Mt. Todd Waste Rock Dump Closure

ASSESSMENT REPORT

VISTA GOLD

July 2020

FIGURE 3.5: WRD INTERLIFT LINER CONFIGURATION (TETRA TECH, 2019B)

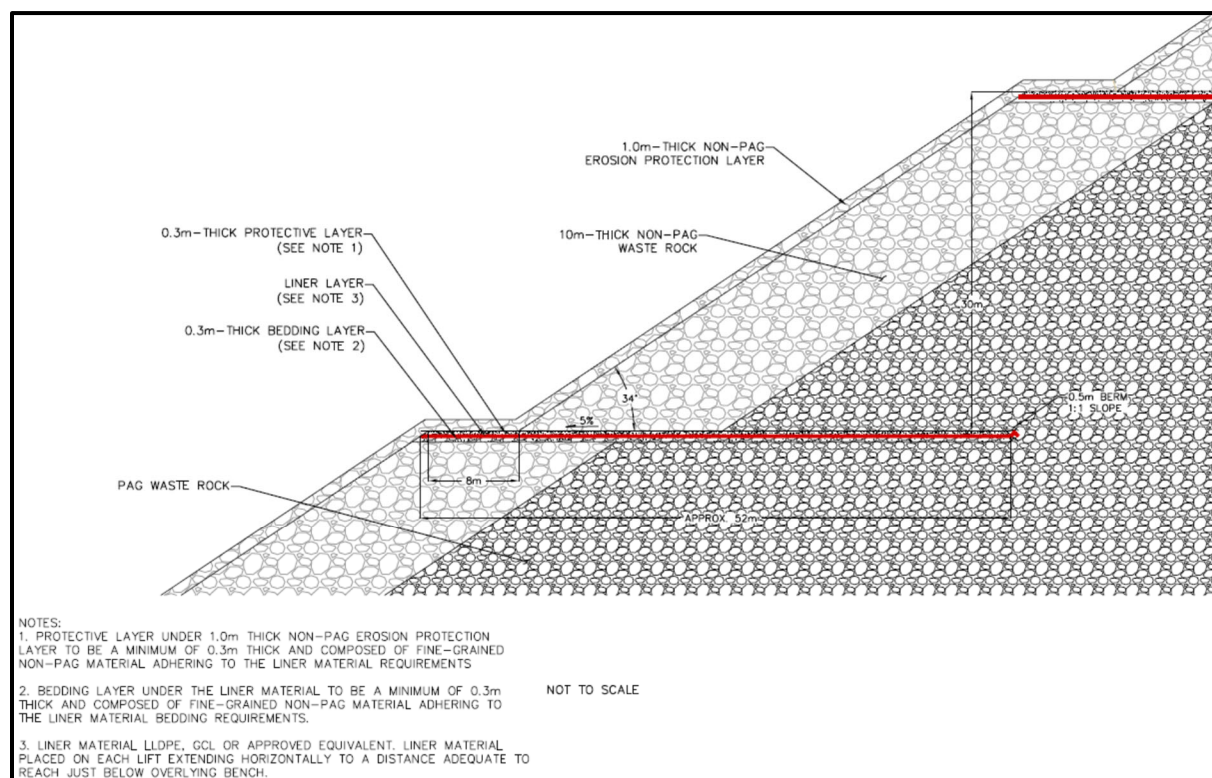
The WRD will be constructed with an encapsulating NAG waste rock outer shell on each waste rock lift. A low permeability liner (GCL or LLDPE) will be installed on top of each 30-m lift (Figure 3.5) as it is completed to limit infiltration into the PAG at the WRD’s core. The liner system will include a 0.3 m thick bedding layer of fine soil to act as a liner cushion and an additional 0.3 m of fine soil will be placed over the liner to prevent damage during waste rock placement. The liner will extend 52 m on top of the completed lift into the dump interior. The waste rock/liner bedding will be graded at 5% to drain to the WRD outer face. At ultimate buildout, a liner will be placed over the regraded WRD top surface to shed water to the WRD perimeter and prevent infiltration into the PAG core.

The proposed petticoat liner system proposed for the WRD introduces a liner (either GCL or LLDPE) into the WRD cross-section every 30 m (vertically). The liners will be installed on waste rock graded at 5% toward the outer WRD slope face. Generally, waste rock has a relatively high internal shear strength, as evidenced by the steep slopes (1.5H:1V of 35 degrees) proposed for the WRD. The introduction of a liner at the base of each 30m lift introduces a “slip plane” that can lead to slope instability. One of the key drivers to stability will be the interface friction angle achieved between the GCL (or LLDPE) and the fine-grained bedding material proposed to protect the liner. In the case of GCL, internal shear of the GCL itself must also be evaluated.

The effectiveness of the petticoat liner system approach to the WRD closure is dependent upon the liner installed on top of each 30m lift to drain intercepted seepage to the WRD bench minimizing contact with PAG waste rock. The liners will be installed at a minimum 5% slope to promote flow to the WRD exterior slope. Truck-placed, end-dumped waste rock will settle over time as additional lifts of waste rock are placed over the initial lifts. A 5% slope over 52 m, provides 2.6 m of vertical relief from the liner initiation point to its end point. The magnitude of waste rock settlement will be driven by the thickness of additional waste rock placed over the liner; areas out near the face will have less coverage (and experience less settlement) than areas under the crest of the next lift. If excessive settlement were to occur, the slope of the liner could be reduced and potentially reversed, allowing collected seepage to flow into the PAG as opposed to avoiding contact. This is stated as an extreme case but is nonetheless possible.

The petticoat liner system relies on intercepting and conveying meteoric water away from PAG waste rock. The effectiveness of the system will be significantly reduced if any of the liner is breached or the permeability increased. GCL has “self-healing” ability due to bentonite swell. Tetra Tech identified the potential for GCL permeability increase due to cation exchange between the seepage water (high in calcium and magnesium) and bentonite in the GCL. The “self-healing” properties may reduce due to the cation exchange issue identified by Tetra Tech. Testing should be completed with site seepage water to determine the potential impact to GCL performance. If LLDPE liner is used in lieu of GCL, consideration must be given to liner puncture that will increase flow through the liner. Liner leakage due to defects (holes or poor quality seams) will likely be of relatively low magnitude due to the limited hydraulic head anticipated on the liners. Other considerations in future liner breach studies should consider liner longevity and potential seismic and/or differential settlement impacts.

Potential waste rock settlement should be evaluated to determine the magnitude of settlement that may be experienced beneath a 30-m waste rock lift to determine if grade reversal is a possibility. If excessive settlement is expected following settlement analysis, lift heights may be reduced in the outer “rind” of the WRD to obtain better waste rock compaction by loaded haul trucks thus minimizing settlement. Adjusting liner grade may also be necessary to compensate for potential grade reversal.

- Evaluate waste rock consolidation under 30-m waste rock load to determine if 5% slope is adequate for positive drainage to WRD outer bench and settlement impacts to liner system integrity (Tierra Group);

FIGURE 3.6: FLUX RATES FROM 2011 ALTERNATIVES ANALYSIS (TETRA TECH, 2018)

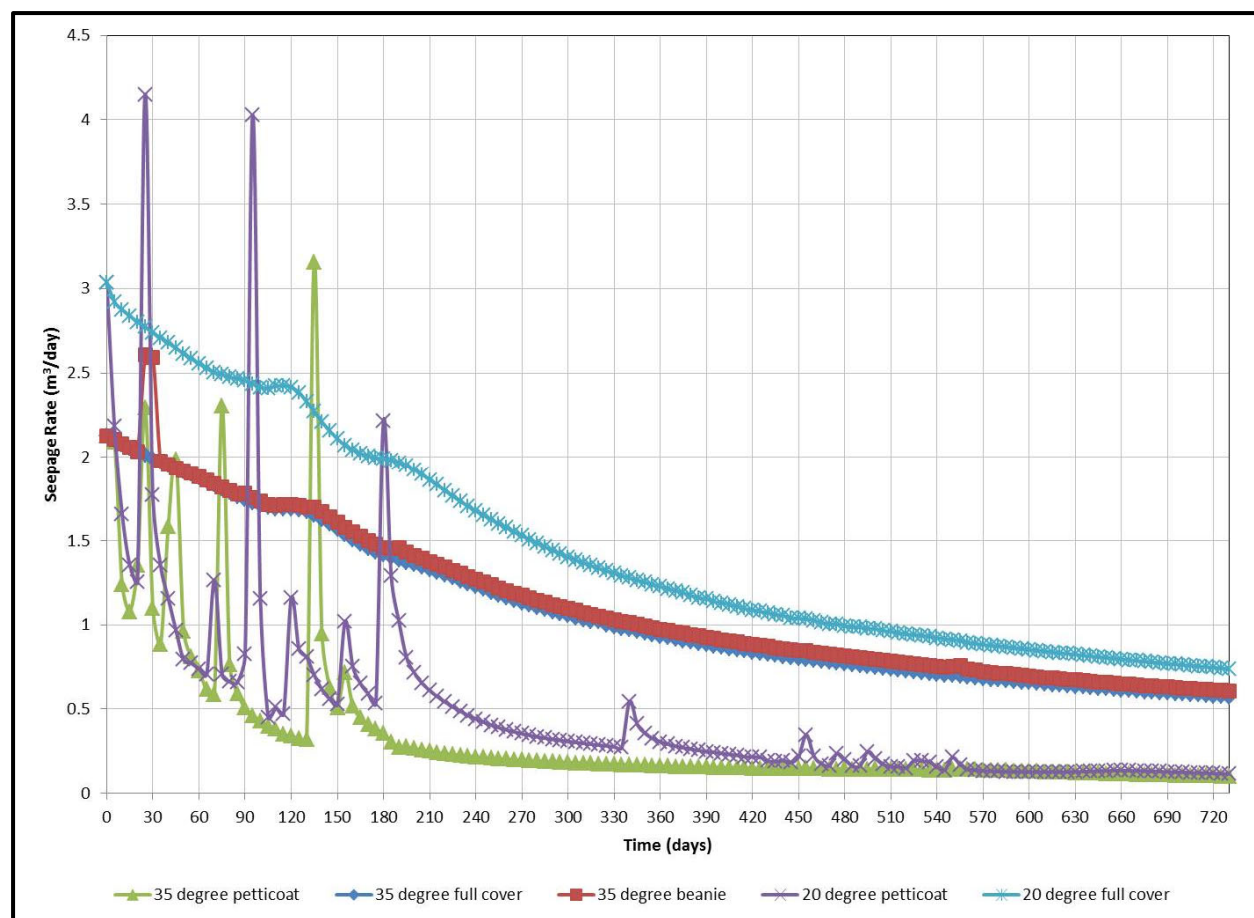
Table 3.1 presents a summary of the results obtained evaluating alternative WRD slope geometries and covers. Figure 3.6 provides a graphical summary of model output, focusing on the predicted seepage rate from the WRD base. Table 3.1 shows that modeling predicts the full cover option would result in the lowest seepage volume from the facility (measured as a percentage of annual precipitation); however, the full cover option has constructability limitations. GCL requires a soil cover providing confining pressure to resist bentonite swelling for optimal permeability performance. A GCL cannot be installed on a 35-degree slope and covered with a fine-grained fill, without significant erosion and soil loss occurring from the slopes. The 20-degree full cover option is limited due to the required footprint for the WRD cover. The 35-degree petticoat option provides the best performance without constructability limitations identified for the full cover options.

FIGURE 3.7: FLUX RATES FROM 2012 SEEPAGE ANALYSIS (TETRA TECH, 2018)

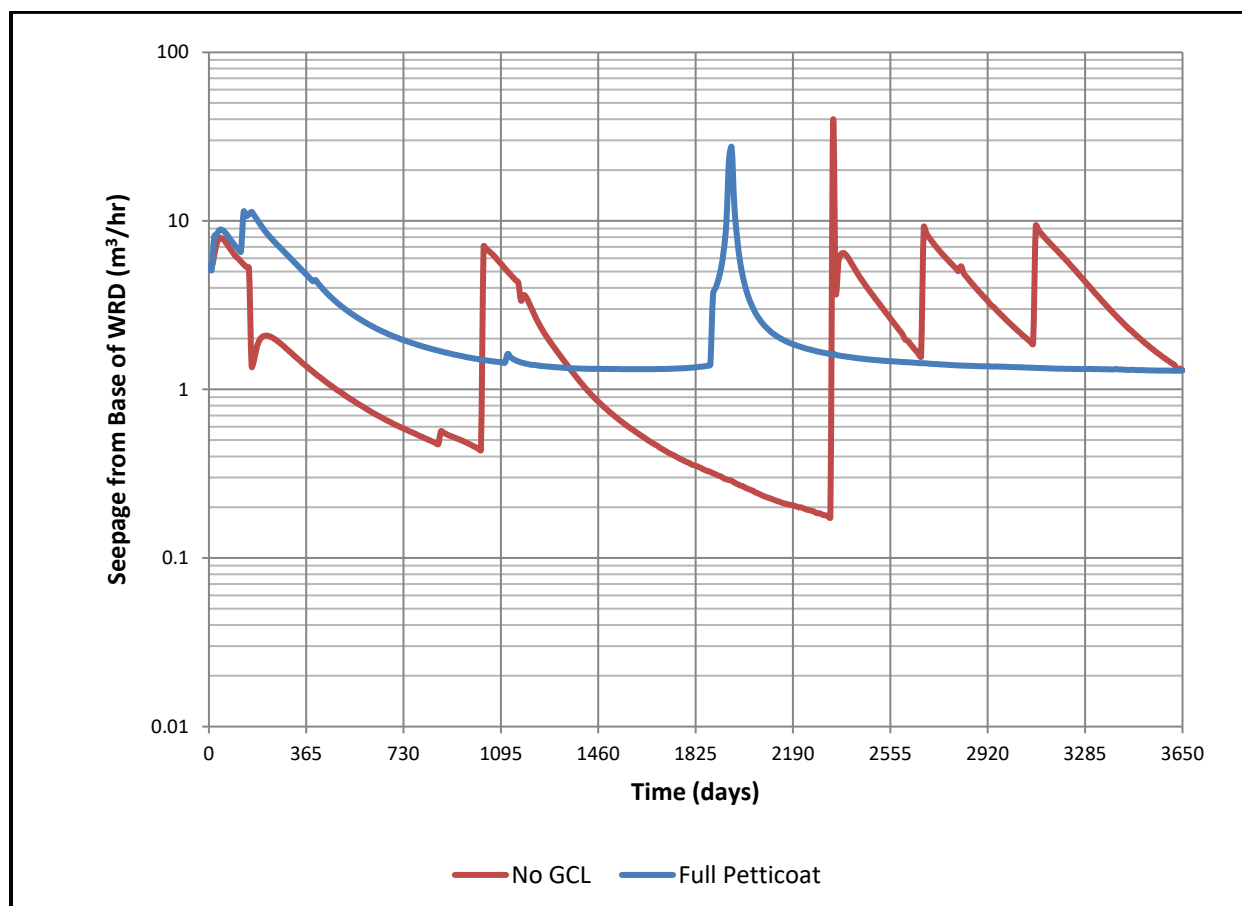
Tetra Tech revisited the petticoat design in 2012, extending the GCL further back along each bench from the outer edge into the waste rock a total of 52 m. The GCL length extends to a point vertically beneath the crest of the subsequent waste rock lift placed over the GCL. This configuration provides a more continuous measure to limit seepage along the outer waste rock shell and prevents contact with the PAG stored in the WRD interior. As can be seen in Table 3.2 and Figure 3.7, extending the length of the GCL significantly reduces the predicted amount of seepage from approximately 13% of annual precipitation down to approximately 7% of annual precipitation in the simulation. The 2012 modeling was completed using the same climate record (1 year of data from Katherine Aviation Museum meteorological station) as the previous modeling, but the model was run for a total of 10 years (as opposed to 3 years in previous modeling).

The VADOSE/W model files were not reviewed as part of this closure assessment. Summary input data, including soil hydraulic property graphs (soil water characteristic curves and unsaturated hydraulic conductivity functions) were provided and appeared to be reasonable for proposed closure design preliminary modeling.

- Update seepage modeling to reflect longer-term climatic condition variation – compare anticipated seepage using GCL (impacted due to cation exchange) versus LLDPE (pinholes due to loading) [Tierra Group];

FIGURE 3.8: EXPECTED WRD FLOW PATHS AND MATERIAL CONTACTS (TETRA TECH, 2019a)

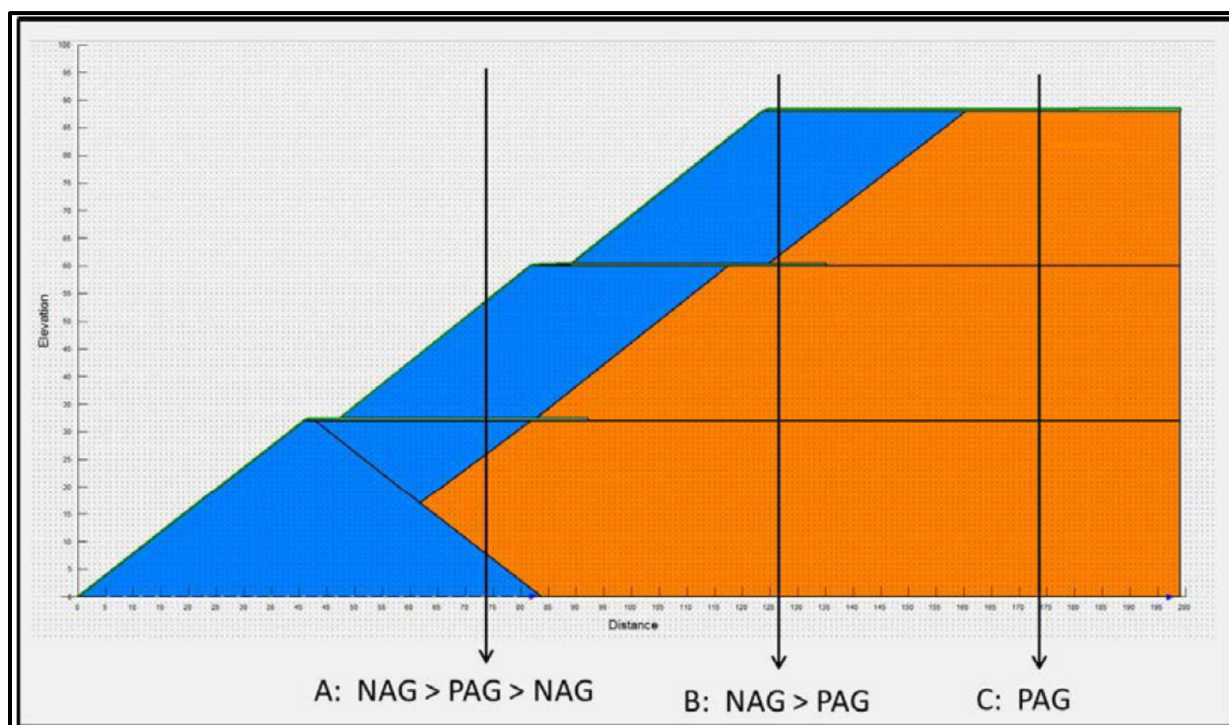
Tetra Tech evaluated resultant seepage water quality using the computer code PHREEQC. The model was used to evaluate the resultant seepage water quality of three potential pathways through the WRD, each containing differing relative amounts of contact with PAG and NAG waste rock. The three paths described by Tetra Tech are presented in Figure 3.8.

Table 3.3 is a summary of predicted water quality from the PHREEQC model. A detailed review of the PHREEQC modeling was not completed by Tierra Group. The results of the modeling appear to be reasonable and follow the anticipated outcome that seepage flowing through PAG resulted in lower pH, higher sulfate concentrations, and higher constituent (metals) loads.
